Memorandum

Subject: Response to comments on CUP Application for the expansion of the Coffin Butte Landfill

The following are responses to public comments received following submittal of the Conditional Use Permit (CUP) application for the Coffin Butte Landfill.

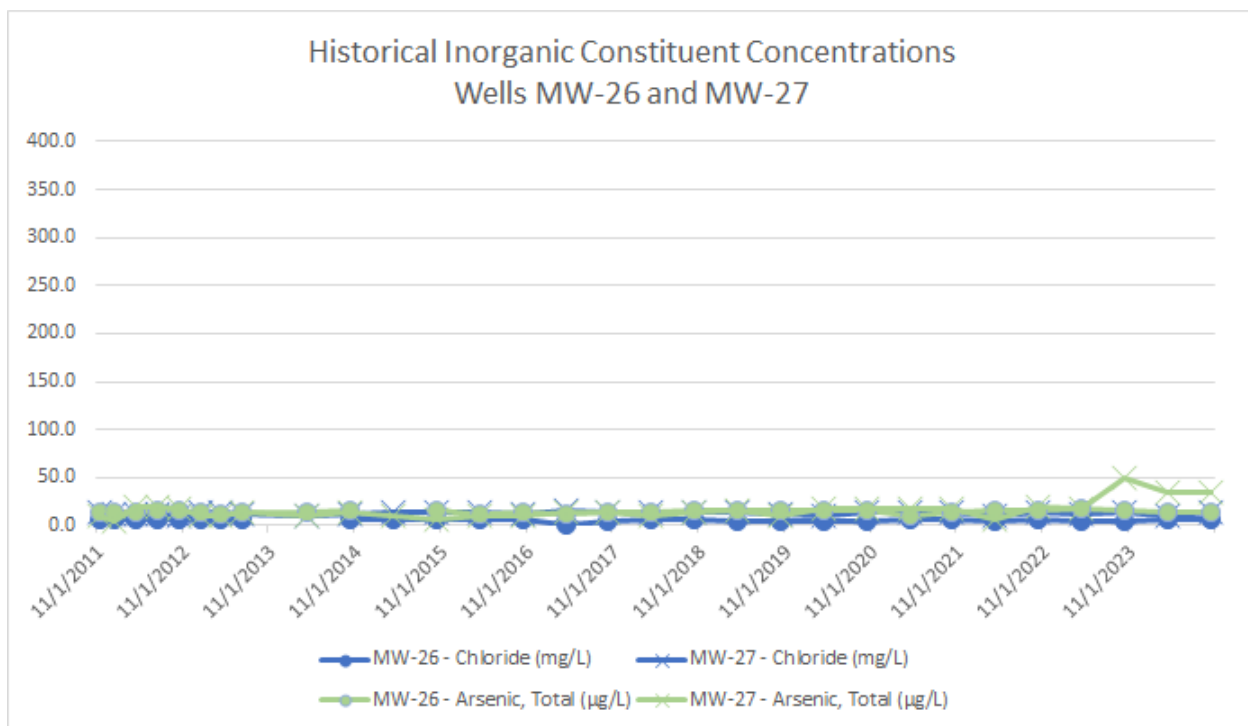
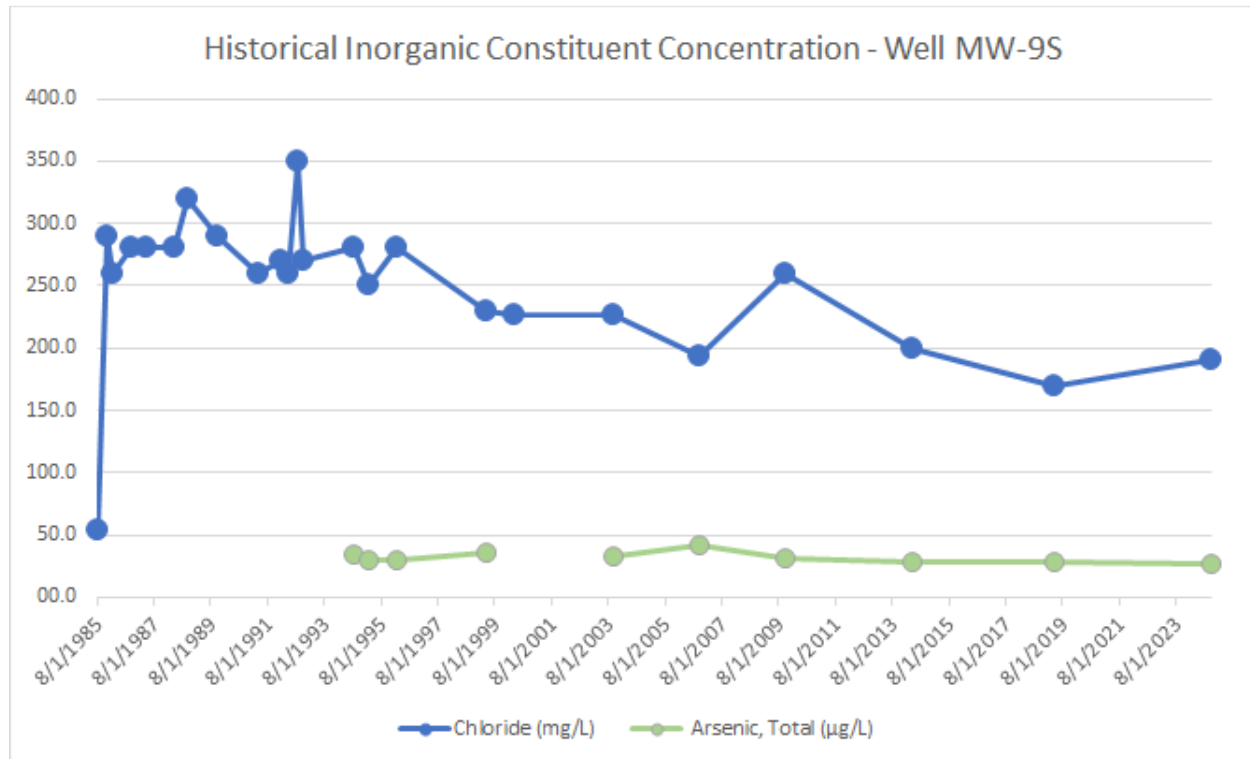
Response to Comments concerning the presence of arsenic in groundwater

VLI has been monitoring groundwater chemistry at the CBL for more than 30 years in accordance with the requirements outlined by the State of Oregon Department of Environmental Quality (ODEQ). VLI acknowledges that since arsenic was first detected at well MW-9S, elevated arsenic concentrations have been detected in wells that monitor the east side of the facility; namely, wells MW-26, MW-27, and MW-9S; however, no monitoring results indicate that these arsenic concentrations are attributed to a leachate discharge. This section will:

- describe the ways leachate impacts to groundwater can be determined, and present historical groundwater chemistry results for the subject wells,
- present public information regarding the basin-wide geochemistry with respect to arsenic and its natural occurrence in the area,
- describe the impacts of low dissolved oxygen content associated with local the natural environmental conditions along the eastern portion of the site, and its effect on arsenic concentrations in this area of the site
- propose actions should a release to groundwater be identified and verified.

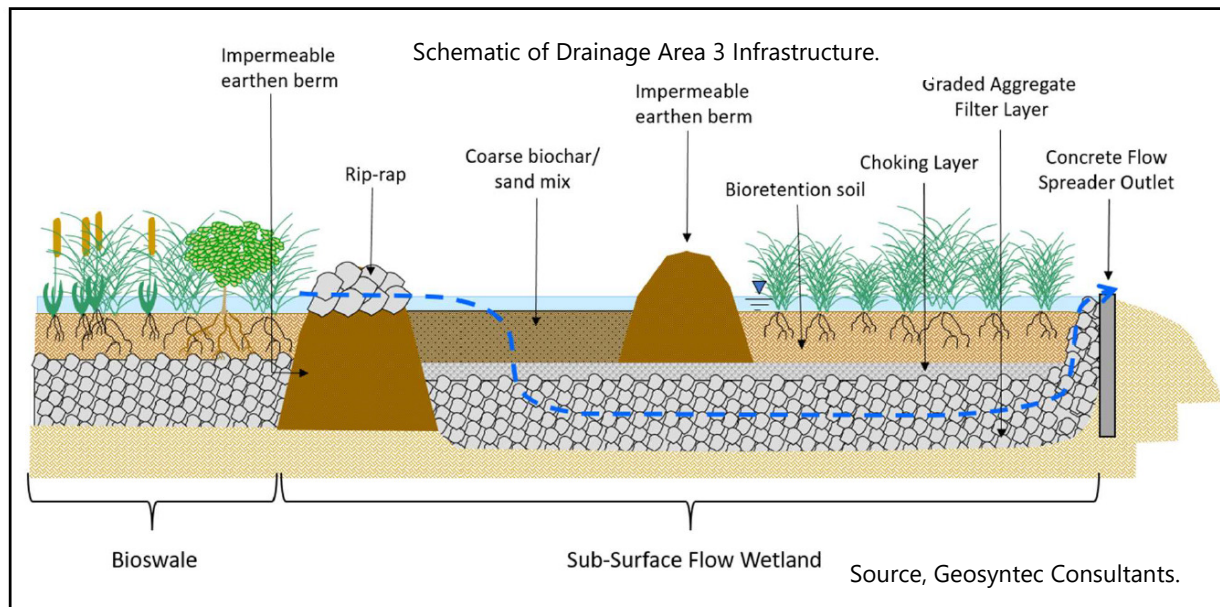
Response to Comments concerning stormwater and surface water management in the current development area.

Existing end-of-pipe BMPs in Drainage Area 3 include two large sedimentation basins, located to the northeast and southeast of the active landfill area, a large bioswale that receives water from both sedimentation ponds, and a subsurface wetland (installed in 2021) that receives effluent from the bioswale. The more northern sedimentation basin (Pond 2) is approximately 32,000 square feet and receives runoff from the areas north of the active landfill through a 30-inch storm pipe. The more southern sedimentation basin (Pond 1) is approximately 26,000 square feet and receives runoff from the active and inactive landfill cells, which generally drain to the east, through a 36-inch storm pipe. Both ponds drain towards the centerline of the landfill area where they combine into a 48-inch storm pipe that drains to the large bioswale, which takes up approximately 45,000 square feet.

In 2021, a portion of the existing east bioswale was converted to a sub-surface flow wetland (SSFW). A conceptual overview of the constructed SSFW is depicted below and includes an impermeable berm bisecting the swale at its northern end that forces water down through a sand/biochar media filter and into a subsurface gravel layer. After passing through the treatment media, water flows horizontally through the gravel layer beneath the impervious berm and re-emerges on the surface on the downstream side. Bioretention media planted with native wetland plants was placed above the gravel layer on the downstream side of the berm. Treated surface water flows over a flow spreader weir at the northern end of the subsurface wetland, where it is sampled, prior to being discharged to Toketie Marsh.

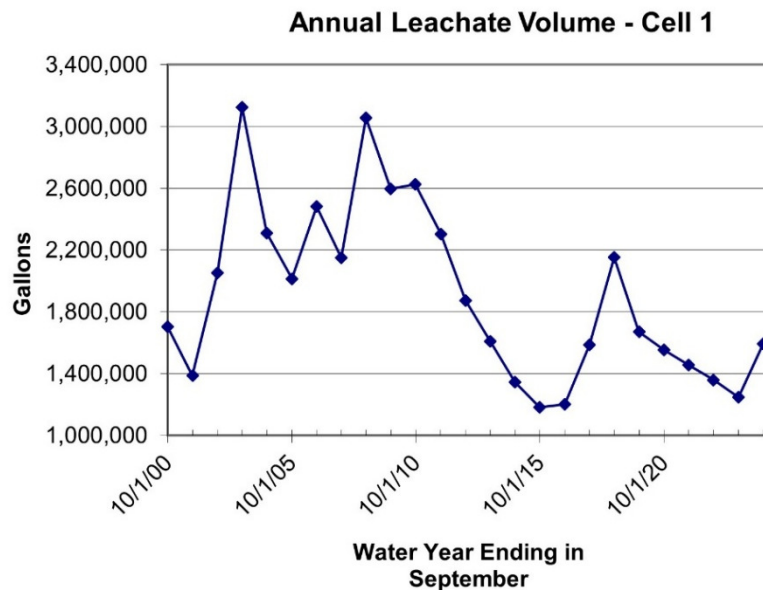
Response to Comments concerning Stormwater and Surface Water Management in the Proposed Development Area

Stormwater from the proposed landfill development area will ultimately be directed toward the east and use existing stormwater controls described in the discussion of stormwater controls for the existing landfill (see preceding response). As presented in the CUP application supporting documentation, the proposed stormwater design captures stormwater using graded swales and conveys the water to catch basins. The catch basins direct stormwater flows to a combined detention and wet pond facility located to the east of the landfill footprint. The purpose of this facility is to slow down the flow rate to allow sediment to settle out of the flow stream before water is discharged. The outflow of onsite stormwater from the wet pond will be conveyed through a graded swale to a 12-inch culvert crossing to the north side of Coffin Butte Road and

As the project design progresses, VLI will develop comprehensive designs for drainage structures. These designs will be supported by hydraulic calculations to demonstrate that each component of the stormwater management system for the proposed development area is sized to accommodate the design storm event for the facility. This procedure is typical of development projects of all types and will be conducted in accordance with the appropriate engineering standards and pertinent regulations. The final drainage system design will be reviewed and approved by ODEQ prior to finalizing the bid documents for construction.

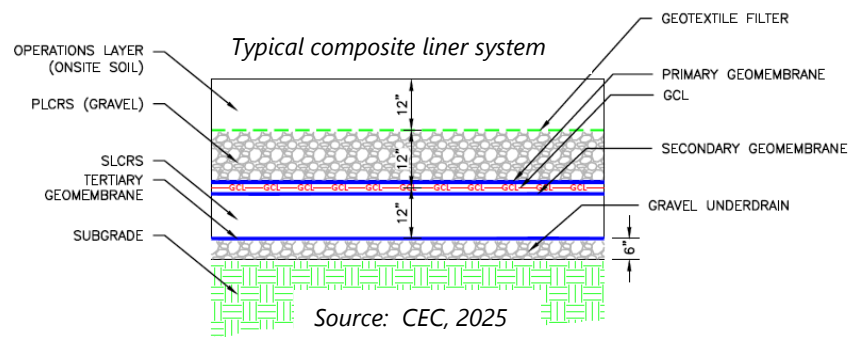
Response to Comments concerning the absence of clay below the liner system.

Cells 1A and 1 were first used for waste disposal in 1975. Both cells were developed prior to the adoption of regulations and practices requiring construction of landfill liner systems, and historical records indicate that minimal excavation was conducted in these areas of the site prior to initiating waste disposal operations. Historical records indicate that Cell 1A was developed on exposed bedrock. The southern portion of the Cell 1 area was originally underlain by native alluvium, and that material was removed prior to waste placement and used to construct an approximately two-foot-thick clay liner over portions of the Cell 1 subgrade and an engineered fill toe berm. In addition, Cell 1 is equipped with a leachate collection system. Leachate is extracted from Cell 1, and is managed in accordance with the terms of the current solid waste permit. Portions of Cell 1 and all of Cell 1A have been formally closed in accordance with Oregon Administrative Rules, Chapter 340, Division 94 (OAR 340) and Federal Subtitle D regulations found in the Code of Federal Regulation, Part 258 (40CFR258).

Acknowledging the absence of modern landfill liner systems that were available at the time these cells were constructed, VLI installed the leachate collection system and numerous groundwater monitoring wells downgradient of these cells. As a result, the leachate collection and monitoring system now meets or exceeds current regulatory standards. These efforts are to remove leachate for proper disposal, and to allow evaluation and appropriate response should changes in groundwater chemistry be detected in this area of the landfill.

COFFIN BUTTE LANDFILL RESPONSE TO COMMENTS - CUP APPLICATION BENTON COUNTY, OREGON			FIGURE NO. 1
GROUNDWATER FLOW CONDITIONS			PROJECT NO. AU24.1090.00
DATE OF ISSUE: 06/11/2025	DRAWN BY: SMD	APPROVED BY: JH

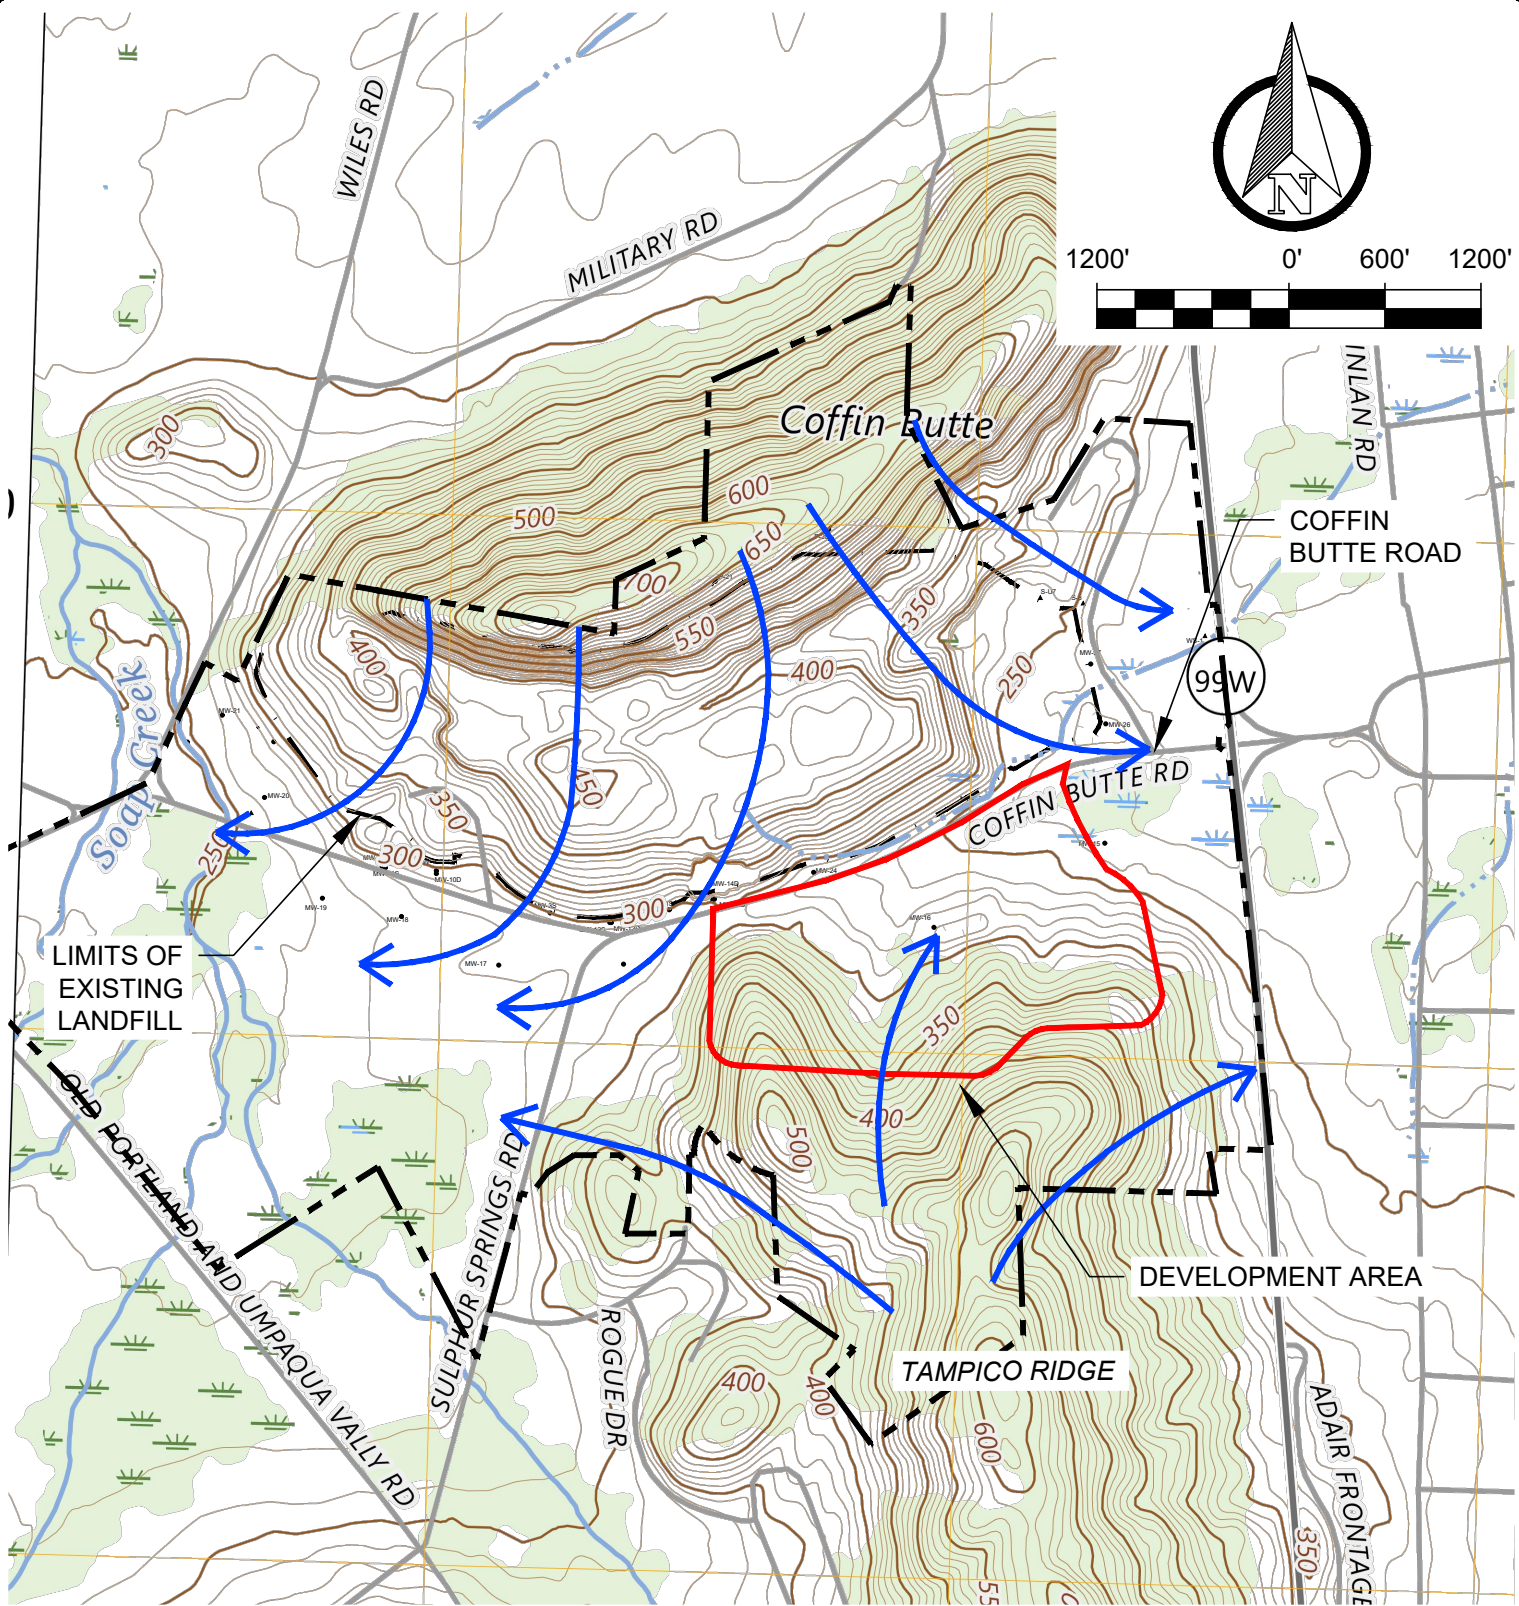
Interruption of groundwater flow associated with the proposed development.

VLI recognizes residents' concerns over the future water supply. As shown in annual groundwater monitoring reports and in Figure 1 (below), we note that the proposed development is located where groundwater flow from Coffin Butte and groundwater flow from Tampico Ridge converge. As a result, the local community south, southwest, and southeast of the proposed development is located upgradient of the proposed development. Groundwater monitoring during development of Cells 1 through 5 has not resulted in a significant change in the groundwater equipotential surface upgradient of these areas of the site as shown in the hydrographs and equipotential surface contour maps that accompany the annual water quality monitoring reports. Recognizing that the geologic conditions beneath the proposed expansion area and Tampico Ridge are similar to those under the existing landfill, modeling results support a conclusion that the proposed expansion is unlikely to result in change in the water resource that is different than the change that occurs seasonally during wet and dry seasons.

COFFIN BUTTE LANDFILL RESPONSE TO COMMENTS - CUP APPLICATION BENTON COUNTY, OREGON DRAINAGE MAP			FIGURE NO. 2
DATE OF ISSUE: 06/11/2025			PROJECT NO. AU24.1090.00
DRAWN BY: SMD			APPROVED BY: JH

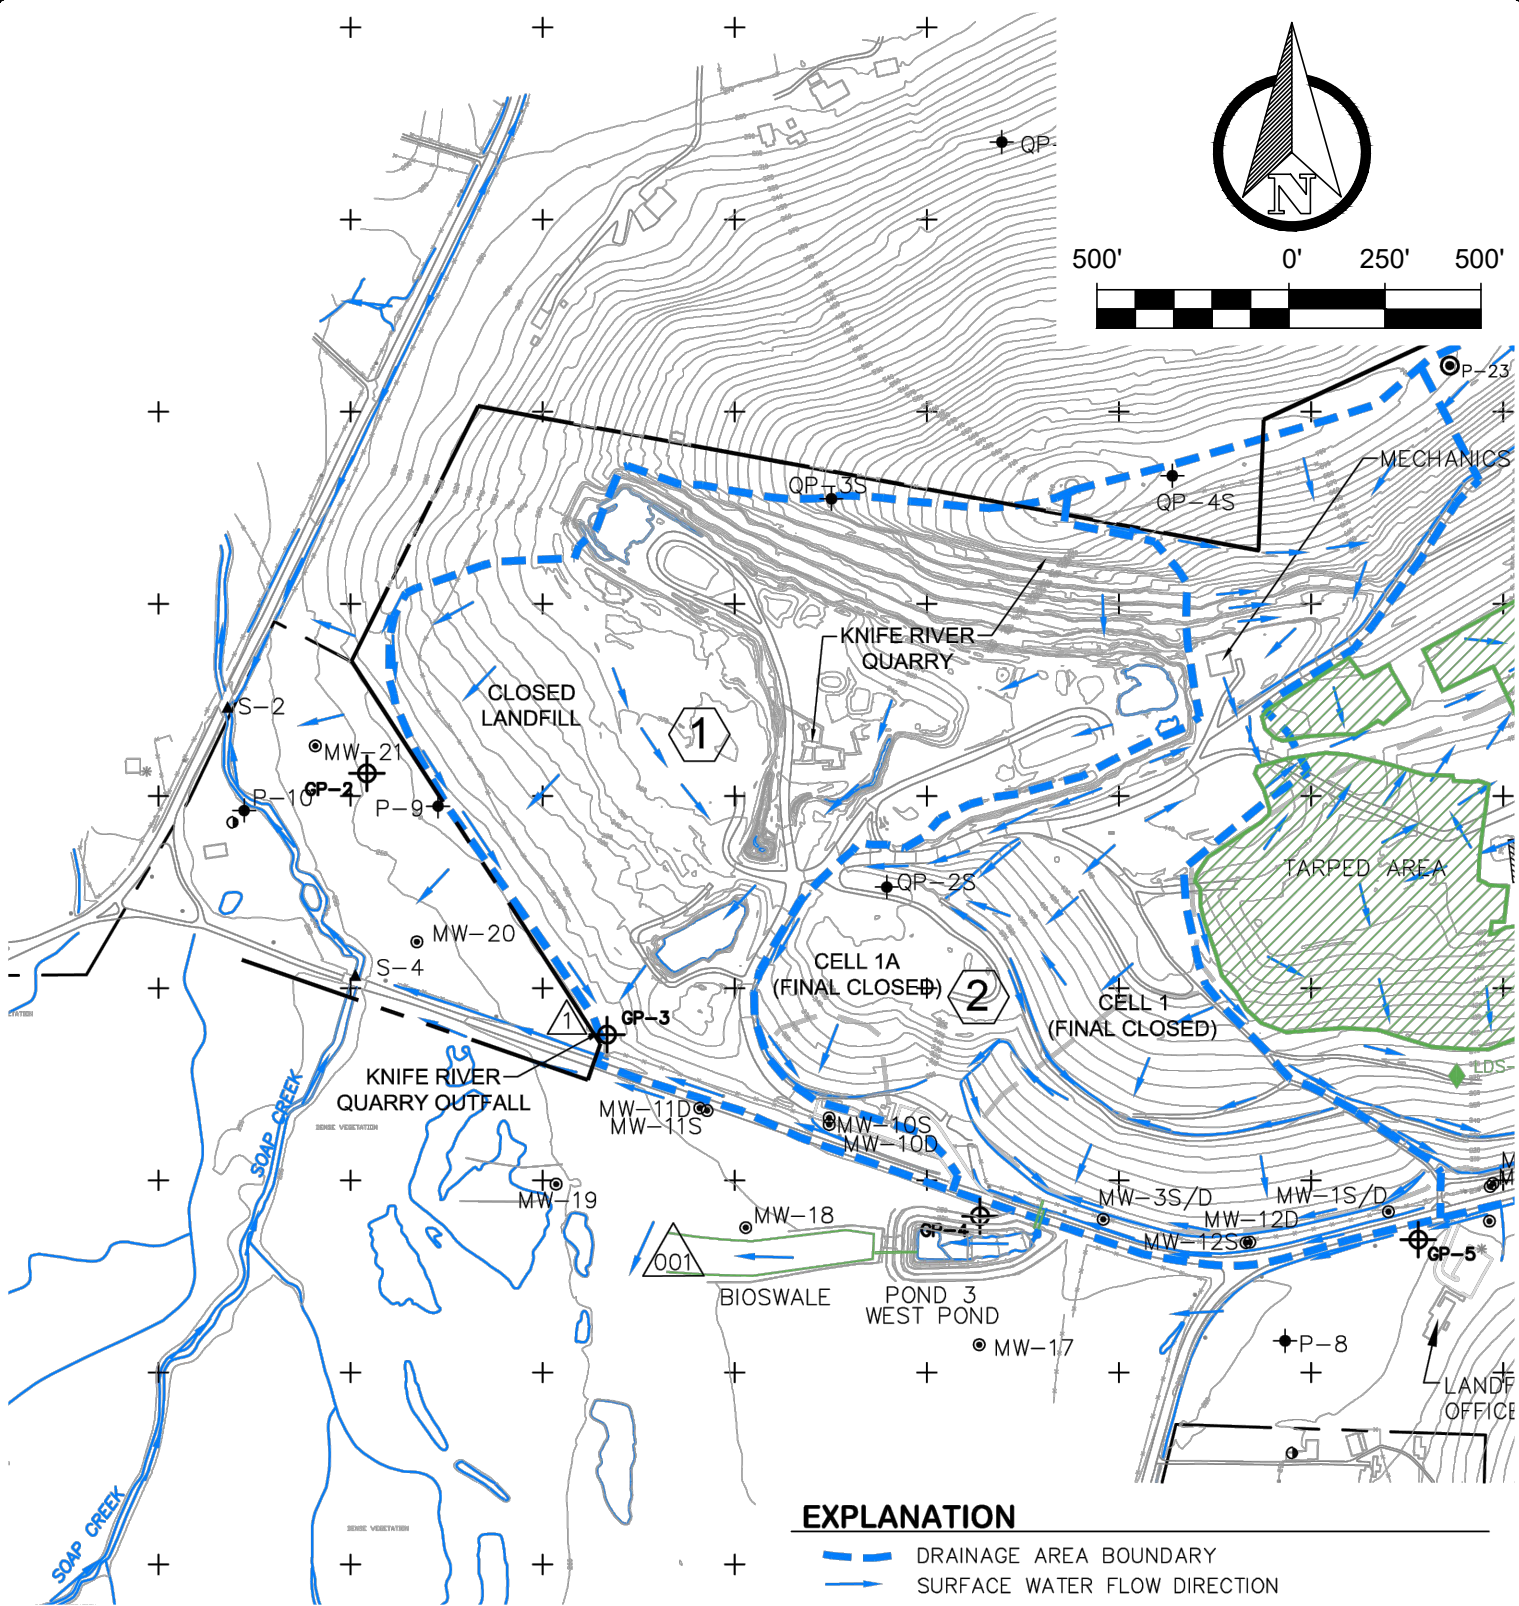
Response to comments concerning current stormwater runoff flowing into Knife River Quarry

A comment reported an observation that stormwater runoff from the existing landfill entered the Knife River quarry pond. Current topography, grading and engineered drainage controls prevent stormwater runoff from the existing landfill from flowing into the Knife River quarry pond. The current stormwater protection plan for the landfill identifies stormwater flow basins based on topography. Site drainage and grading direct stormwater runoff away from the quarry operations. VLI notes that stormwater in the western part of the landfill, primarily the closed parts of Cell 1 and closed Cell 1A, flows within what is referred to as Drainage Area 2 and discharges to Outfall 001. Although this drainage area shares a common boundary (based on topography) with the Knife River drainage area; existing grades and engineered controls are designed to prevent stormwater runoff from landfill areas comingling with runoff from the quarry area, as shown in Figure 2.
